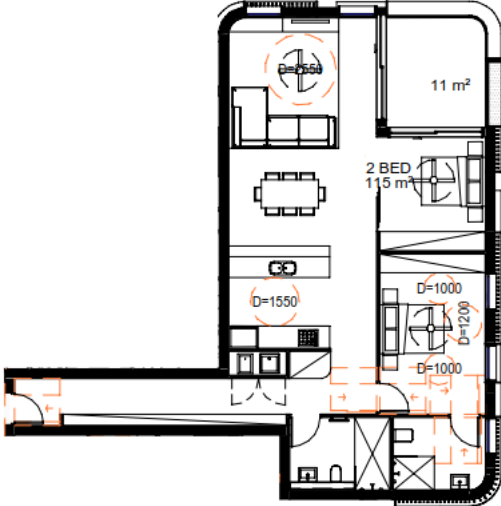
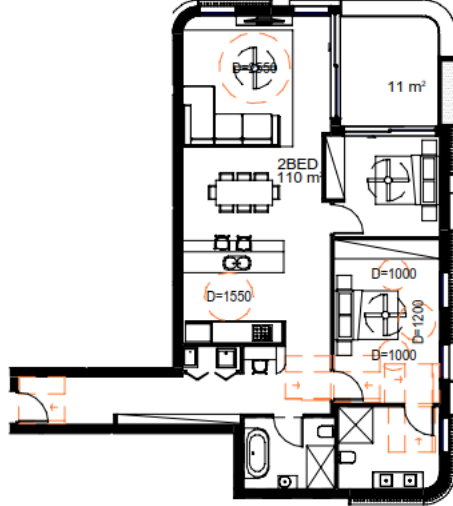
APARTMENT NO.	DESCRIPTION OF AMENDMENT/S	RATIONALE
A101	<ol style="list-style-type: none"> 1. Bath added to the bathroom. 2. Media / storage space added. 3. Bedroom 2 enclosed with the hinge door replacing sliding door. 	<p>Improved layout and increased amenity:</p> <ul style="list-style-type: none"> • Inclusion of a bath • Inclusion of a media / storage space; and • An enclosed Bedroom 2.
<div style="display: flex; justify-content: space-around; align-items: center;"> <div style="text-align: center;">  <p>APPROVED LAYOUT</p> </div> <div style="text-align: center;">  <p>PROPOSED LAYOUT</p> </div> </div>

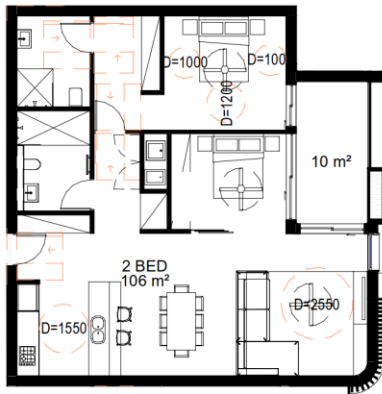
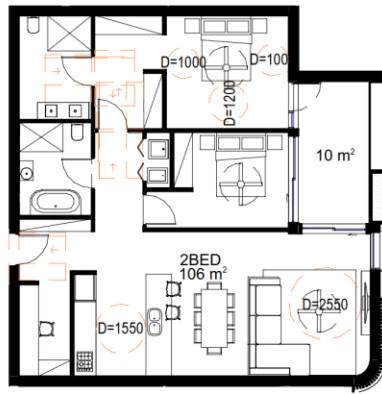
APARTMENT NO.	DESCRIPTION OF AMENDMENT/S	RATIONALE
A201 / A301 (Level 2 shown)	<ol style="list-style-type: none"> 1. Bath added to the bathroom. 2. Media / storage space added. 3. Bedroom 2 enclosed with the hinge door replacing sliding door. 	<p>Improved layout and increased amenity:</p> <ul style="list-style-type: none"> • Inclusion of a bath • Inclusion of a media / storage space; and • An enclosed Bedroom 2.
<div style="display: flex; justify-content: space-around; align-items: center;"> <div style="text-align: center;">  <p>APPROVED LAYOUT</p> </div> <div style="text-align: center;">  <p>PROPOSED LAYOUT</p> </div> </div>

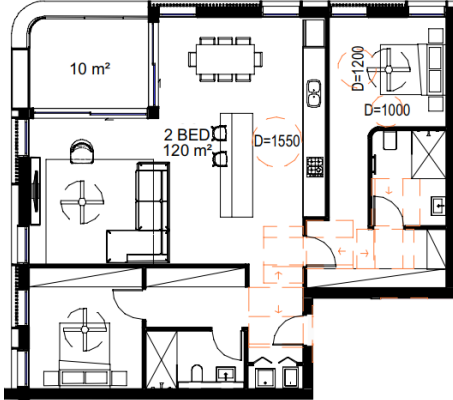
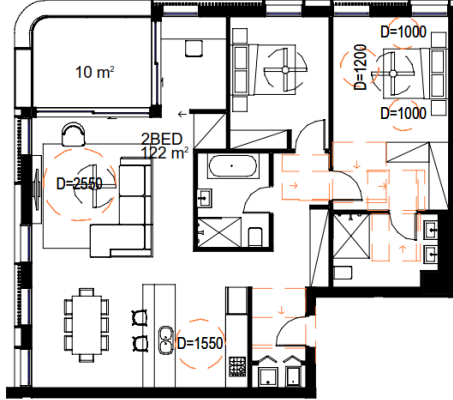
APARTMENT NO.	DESCRIPTION OF AMENDMENT/S	RATIONALE
A103	<ol style="list-style-type: none"> 1. Bath added to the bathroom. 2. Media / storage space added. 3. Bedroom 2 enclosed with the hinge door replacing sliding door. 	Improved layout and increased amenity: <ul style="list-style-type: none"> • Inclusion of a bath • Inclusion of a media / storage space; and • An enclosed Bedroom 2.
<div style="display: flex; justify-content: space-around; align-items: flex-end;"> <div style="text-align: center;">  <p>APPROVED LAYOUT</p> </div> <div style="text-align: center;">  <p>PROPOSED LAYOUT</p> </div> </div>

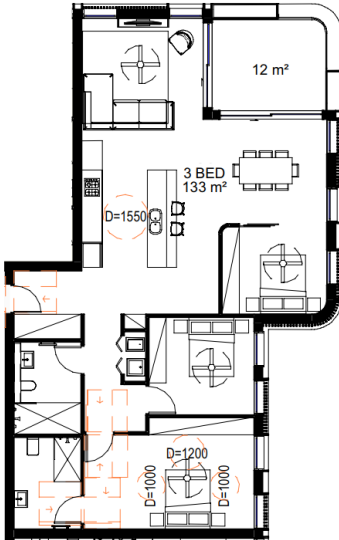
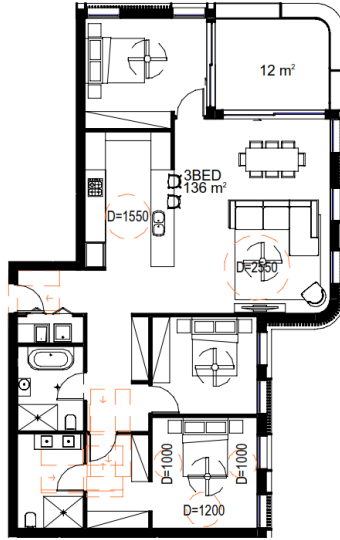
APARTMENT NO.	DESCRIPTION OF AMENDMENT/S	RATIONALE
A203 / A303 (Level 2 shown)	<ol style="list-style-type: none"> 1. Bath added to the bathroom. 2. Media / storage space added. 3. Bedroom 2 enclosed with the hinge door replacing sliding door. 	<p>Improved layout and increased amenity:</p> <ul style="list-style-type: none"> • Inclusion of a bath • Inclusion of a media / storage space; and • An enclosed Bedroom 2.
<div style="display: flex; justify-content: space-around; align-items: center;"> <div style="text-align: center;">  <p>APPROVED LAYOUT</p> </div> <div style="text-align: center;">  <p>PROPOSED LAYOUT</p> </div> </div>

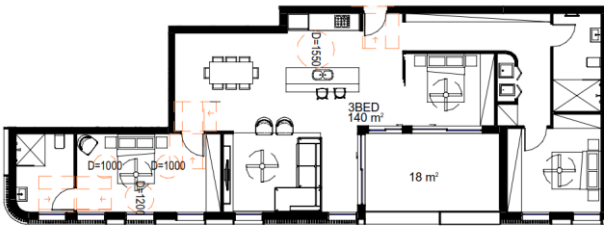
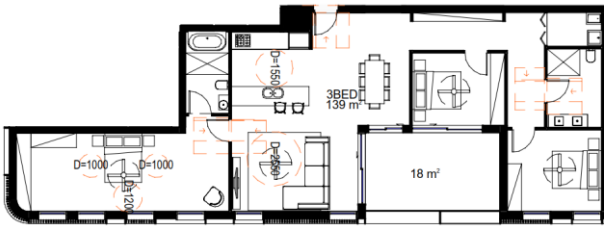
APARTMENT NO.	DESCRIPTION OF AMENDMENT/S	RATIONALE
A104 / A204 / A304 (Level 2 shown)	<ol style="list-style-type: none"> 1. Bath added to the bathroom. 2. Media / storage space added. 3. Bedroom 2 enclosed with the hinge door replacing sliding door. 	<p>Improved layout and increased amenity:</p> <ul style="list-style-type: none"> • Inclusion of a bath • Inclusion of a media / storage space; and • An enclosed Bedroom 2.
<div style="display: flex; justify-content: space-around; align-items: center;"> <div style="text-align: center;">  <p>APPROVED LAYOUT</p> </div> <div style="text-align: center;">  <p>PROPOSED LAYOUT</p> </div> </div>

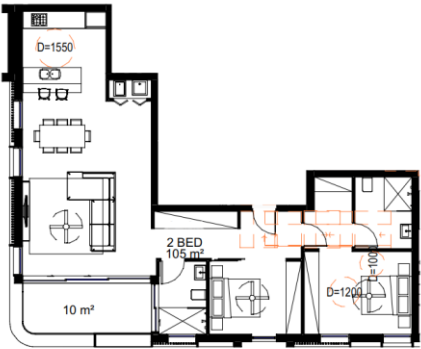
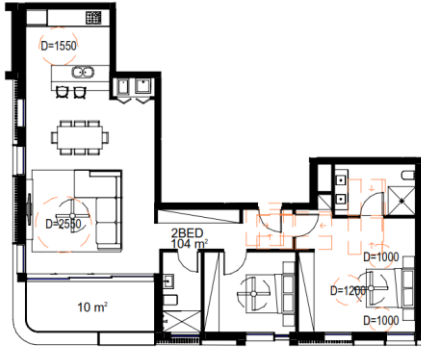
APARTMENT NO.	DESCRIPTION OF AMENDMENT/S	RATIONALE
A401 / A501 (Level 5 shown)	<ol style="list-style-type: none"> Bedroom 2 relocated to the north façade. Kitchen relocated to southern end of apartment. Dining relocated to west façade. Study room added. Bathroom relocated and bath added. 	<p>Improved layout and increased amenity:</p> <ul style="list-style-type: none"> Inclusion of a study room Inclusion kitchen, living and dining layout; and Inclusion of a bath
<div style="display: flex; justify-content: space-around; align-items: flex-end;"> <div style="text-align: center;">  <p>APPROVED LAYOUT</p> </div> <div style="text-align: center;">  <p>PROPOSED LAYOUT</p> </div> </div>

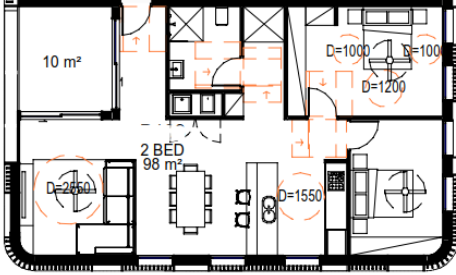
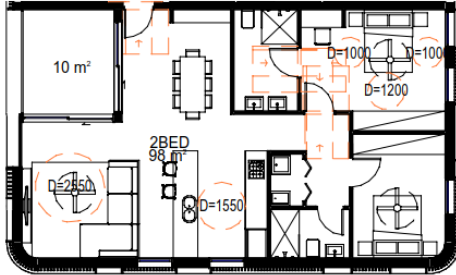
APARTMENT NO.	DESCRIPTION OF AMENDMENT/S	RATIONALE
A402 / A502 (Level 5 shown)	<ol style="list-style-type: none"> Bedroom 3 relocated to the north façade. Living room relocated to east façade adjacent to dining. Bath added to bathroom. Laundry relocated. 	<p>Improved layout and increased amenity:</p> <ul style="list-style-type: none"> Inclusion of a bath Improved kitchen, living and dining layout; and Larger laundry space.
<div style="display: flex; justify-content: space-around; align-items: flex-end;"> <div style="text-align: center;">  <p>APPROVED LAYOUT</p> </div> <div style="text-align: center;">  <p>PROPOSED LAYOUT</p> </div> </div>

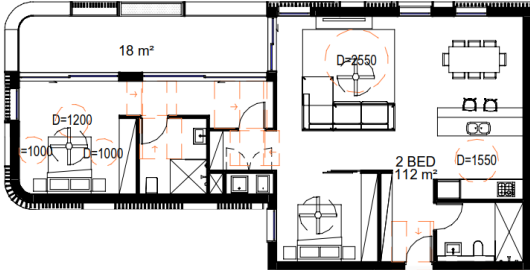
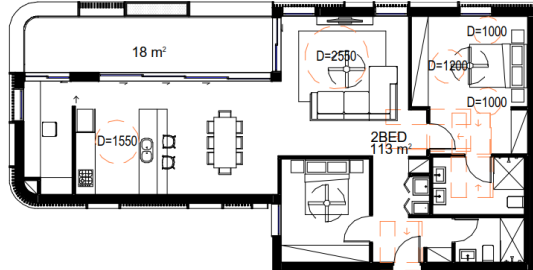
APARTMENT NO.	DESCRIPTION OF AMENDMENT/S	RATIONALE
A403 / A503 (Level 5 shown)	<ol style="list-style-type: none"> 1. Ensuite relocated 2. Kitchen and dining room location swapped 3. Laundry relocated 6. Bedroom 2 enclosed with the hinge door replacing sliding door. 	<p>Ensuite bathroom relocated due to it being located over a habitable room which has acoustic and drainage requirements and leads to an inability to achieve the ADG guided floor to ceiling height below of 2700mm in habitable rooms.</p> <p>Improved layout and increased amenity:</p> <ul style="list-style-type: none"> • Inclusion of a bath • Improved kitchen, living and dining layout; and • Walk in laundry included.
<div style="text-align: center;">  <p>APPROVED LAYOUT</p>  <p>PROPOSED LAYOUT</p> </div>

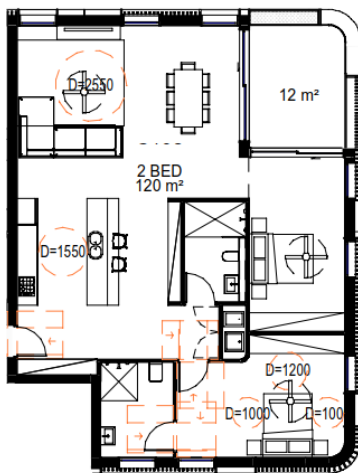
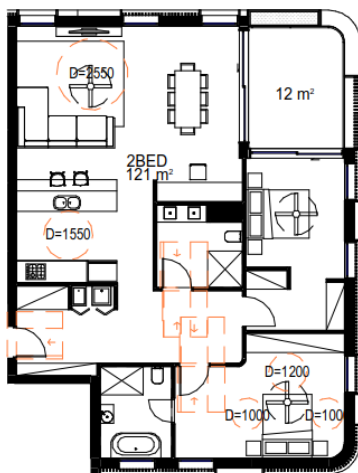
APARTMENT NO.	DESCRIPTION OF AMENDMENT/S	RATIONALE
A404 / A504 (Level 5 shown)	<ol style="list-style-type: none"> 1. Bedroom 2 enclosed with the hinge door replacing sliding door. 2. Bathroom glazed sliding door removed. 3. Bedroom 2 window widened. 	<p>An inconsistency between the DA approved Block A Elevations and the Level 4 and Level 5 plans required updating in this modification.</p> <p>The location and layout of the bathroom cannot accommodate a sliding door to the balcony therefore, the glazed sliding door was replaced with a solid wall.</p> <p>Improved layout and increased amenity:</p> <ul style="list-style-type: none"> • Inclusion of a bath.
<div style="text-align: center;">  <p>APPROVED LAYOUT</p>  <p>PROPOSED LAYOUT</p> </div>
